From: Sara Roediger, AICP  
 Date: 8/2/2016  
 Re: **Culvers (City File #16-015)**  
**Preliminary/Final Site Plan - Planning Review #2**

From: Craig McEwen, Building Inspector/Plan Reviewer *CPM*  
To: Sara Roediger, Planning Department  
Date: July 20, 2016  
Re: Culver's of Rochester Hills  
Sidwell: 15-35-100-053  
City File: 16-015

From: Jason Boughton, AC, Engineering Utilities Coordinator  
To: Sara Roediger, Manager of Planning  
Date: July 27, 2016  
Re: Culver's, City File #16-015, Section 35  
Site Plan Review #2

From: Michael Taunt, Survey Technician  
To: Sara Roediger, Manager of Planning  
Date: July 14, 2016  
Re: Culver's, City File #16-015, Section #35  
Legal Review #1

**RE Site Plan Sheet C1.0**

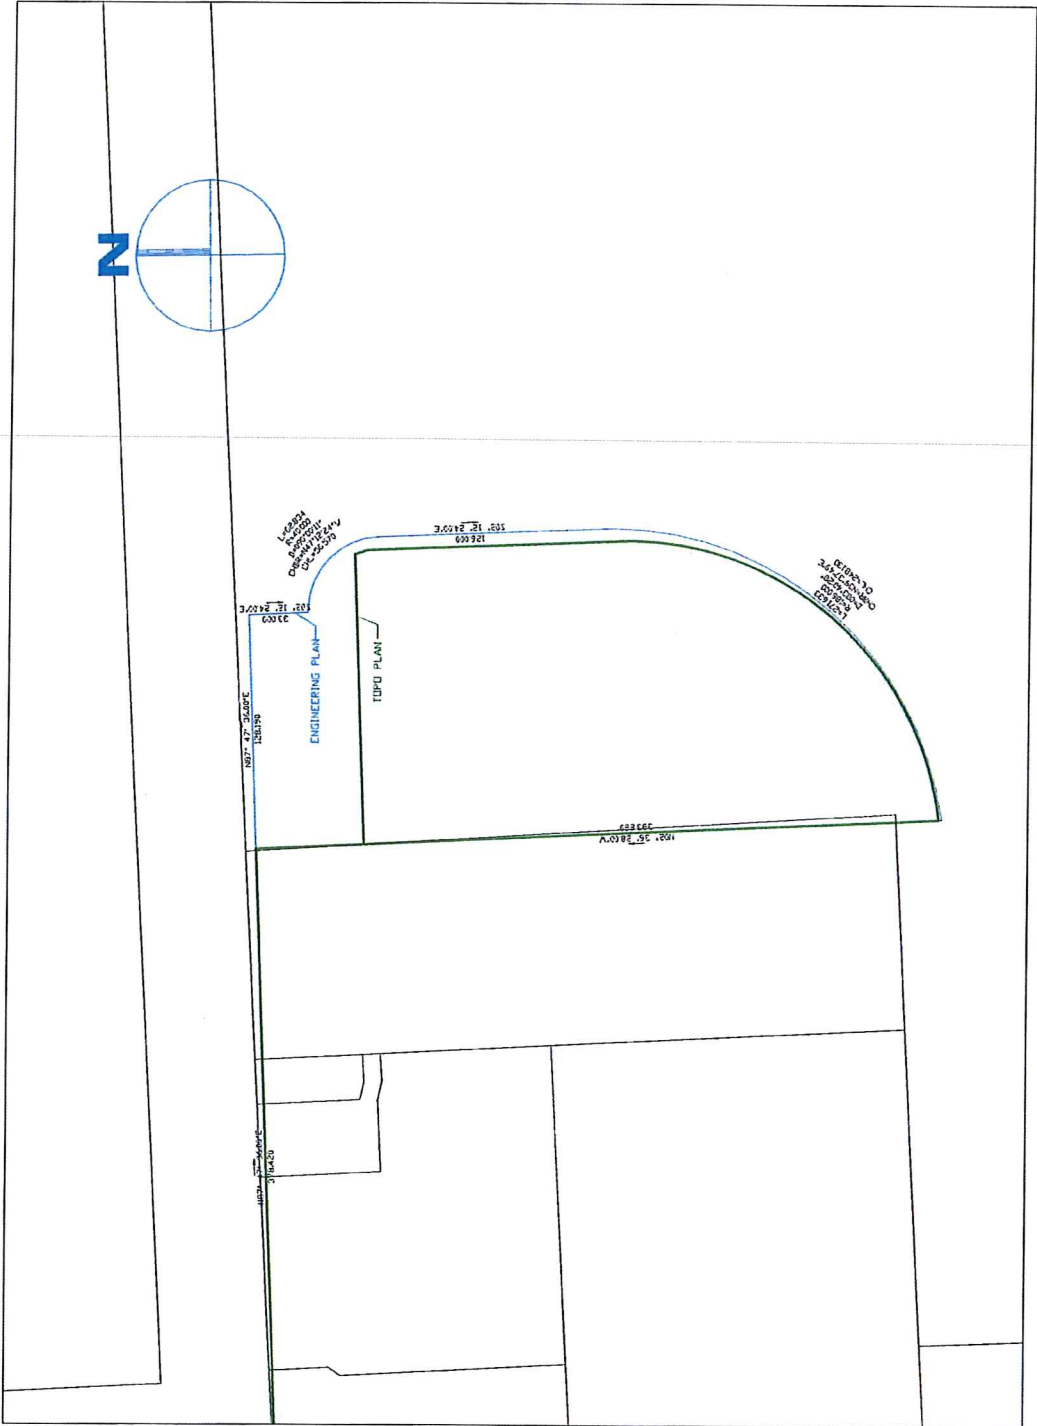
The plans presented contain two legal descriptions, Site Plan Sheet C1.0 & the topographic survey by Thomas M. Smith P.S., which are substantially different. Please resolve.

- The bearing for the fourth course in the boundary description does not match the drawing (S 00° 12'24" E vs. S 02° 12'24" E).
- The legal description closes using dimensions on the plan. The areas, both net and gross are confirmed. Please clarify whether the 60' ROW is deed, easement or proposed.
